## **RESPONSIVE SUMMARY FOR STATE IMPLEMENTATION PLAN REVISION:**

### **Revisions to the Arkansas State Implementation Plan Regional Haze SIP Revision for the 2018 – 2028 Planning Period**

**Figure 2.1:** The Continuum of Accuracy for Cost Analyses

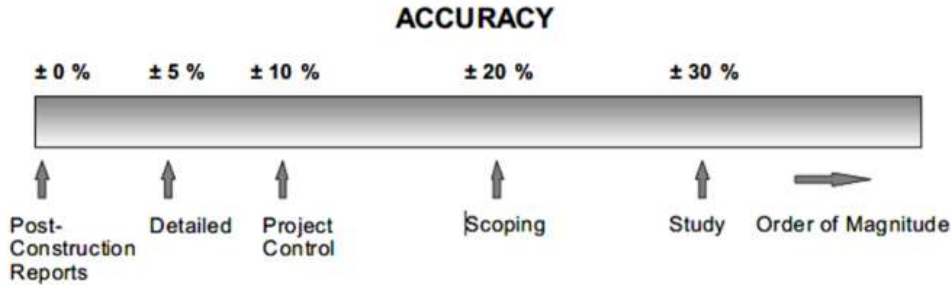
Comment 20:

The 7th Edition of the EPA Cost Control Manual became final in 2021. FutureFuel submitted these cost estimates in April 2020. The EPA/452/B-02-001 EPA Air Pollution Cost Control Module (Sixth Edition of January 2002), as well as the 7th Edition, discusses contingency factors Section 1, Chapter 2.2. The manual provides guidance on the accuracy of cost estimates at different phases of a project. They describe a Study Phase, Scope Phase, Project Control Phase, and a Detailed Phase. Guidance is provided on the cost accuracy of each phase and is shown in Figure 2.1.

FutureFuel firmly believes at this stage of this process that during the Study Phase, a 30% contingency is appropriate and in agreement with EPA guidance. As noted in the proposed SIP, DEQ finds that a 20% contingency is a more conservative estimate and consistent with EPA guidance. The application of evaluated technology to boilers similar to FutureFuel’s is limited and the values used by FutureFuel for capital costs are based on cost estimation tools rather than vendor-supplied estimates. Therefore, DEQ concludes the estimated cost using EPA tools is most reasonably characterized as “scoping,” which EPA guidance indicates has a 20% accuracy.

Figure 1: Low-Income Energy Burden by State (% of Income)<sup>14</sup>

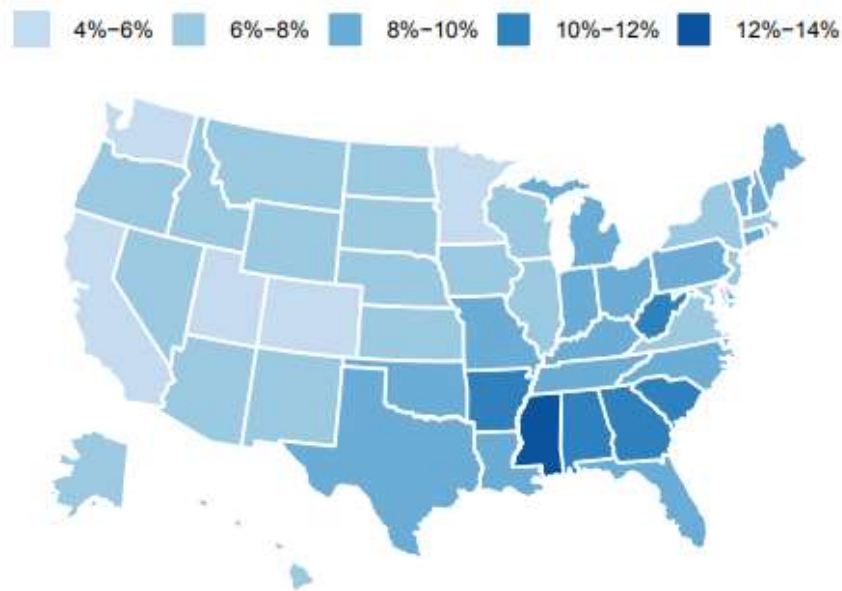
Comment 54:

Two commenters recommended addressing environmental justice, as outlined in EPA's July 8, 2021 Clarifications Memo, "Clarifications Regarding Regional Haze State Implementation Plans for the Second Implementation Period."

In addition, DEQ’s strategy for Planning Period II takes economic justice into consideration in its discussion of the cost of compliance for EGUs analyzed under the four reasonable progress factors. Low-income Arkansas households are subject to a statistically higher energy burden than low-income households in other states. In a similar situation with Arkansas, Louisiana, Mississippi, Alabama, Georgia, and West Virginia are also justified (and ethically obligated) to consider the cost of compliance in large-scale planning that affects energy costs for taxpayers. These states all have historically higher rates of poverty per capita than other states, and also have the highest energy-to-income ratios for lower-income families than any other states in the nation. For perspective, low-income households<sup>12</sup> in Arkansas use 36% more electricity than the national average for low-income households, and the energy burden for these families is 10-12% of the family’s income. Nationwide, only Mississippi has a higher energy burden at 12-14%,<sup>13</sup> as illustrated in Figure 1.
